REMARKS

Entry of this Amendment and reconsideration are respectfully requested in light of the amendments made to the claims and the remarks made herein.

FIG. 13

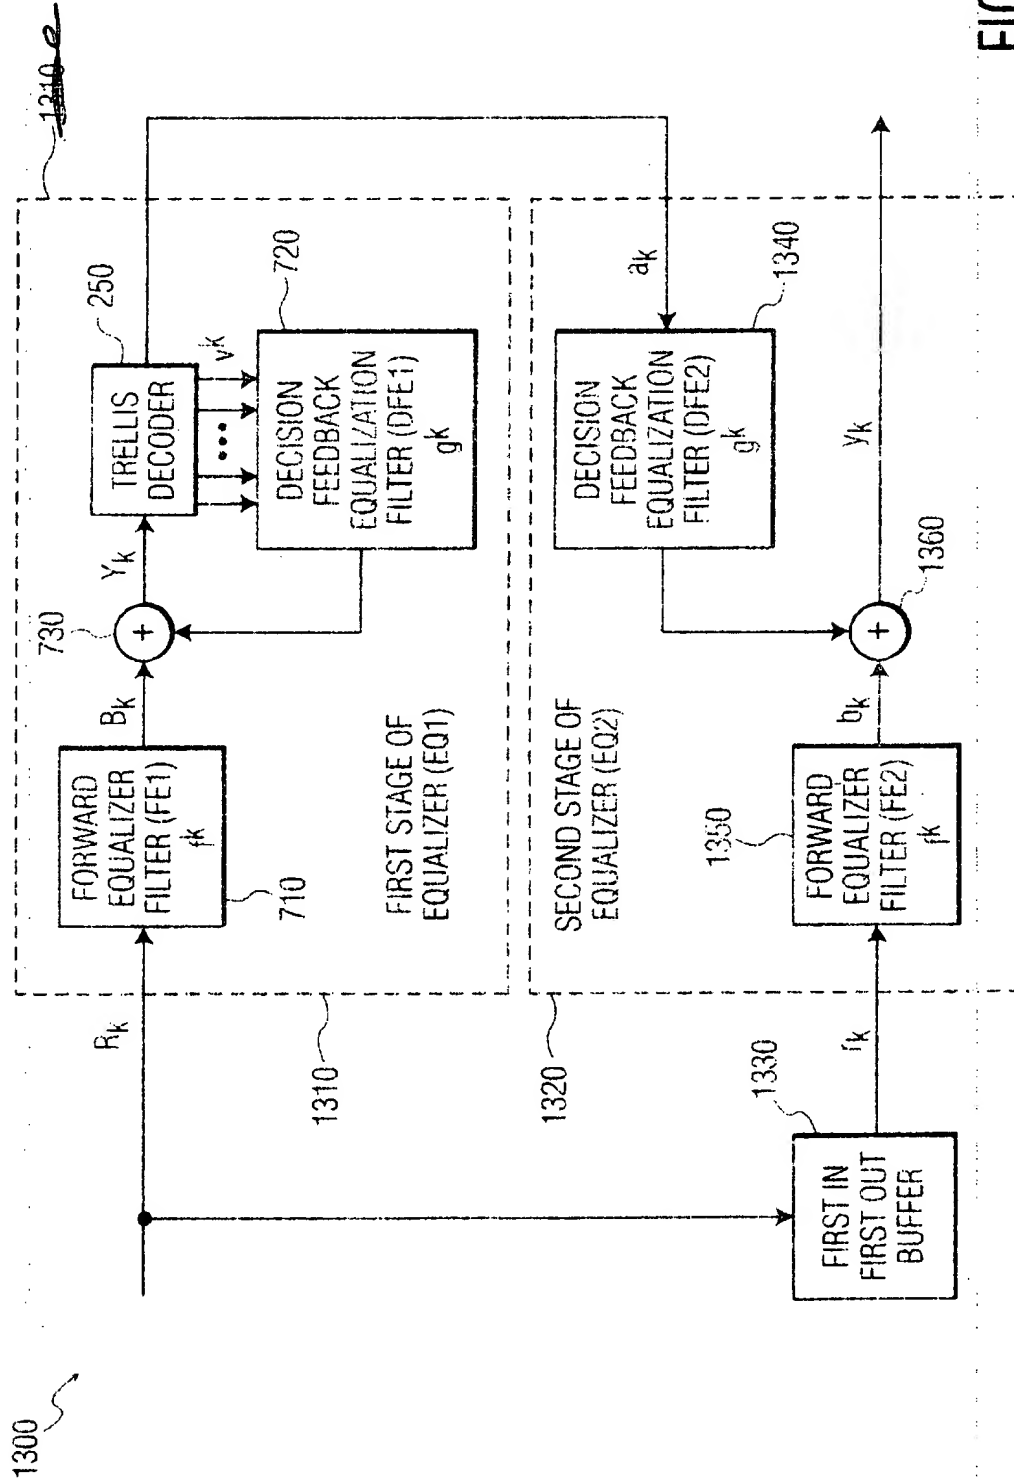
The examiner has objected to the drawings. More specifically, in Fig. 13 the reference number 1310 is duplicated.

Applicant thanks the examiner for his observation and has provided, in Appendix A, an amended Fig. 13, appropriately labeled "Replacement Drawing," which removes the duplicate label 1310. No new matter has been added as the label 1310 was incorrectly duplicated in referring to the same element when formal drawings were submitted in a letter to the Official Draftsman on April 24, 2002. Included, in Appendix B for the examiner's reference, is an annotated copy of the Fig. 13 showing the amendments made, in red, and in Appendix C the originally filed drawing Fig. 13.

Having amended the drawings appropriately, applicant believes that the reason for the examiner's objection is not longer applicable. Applicant respectfully requests that the amended Fig. 13 be entered and the objection withdrawn.
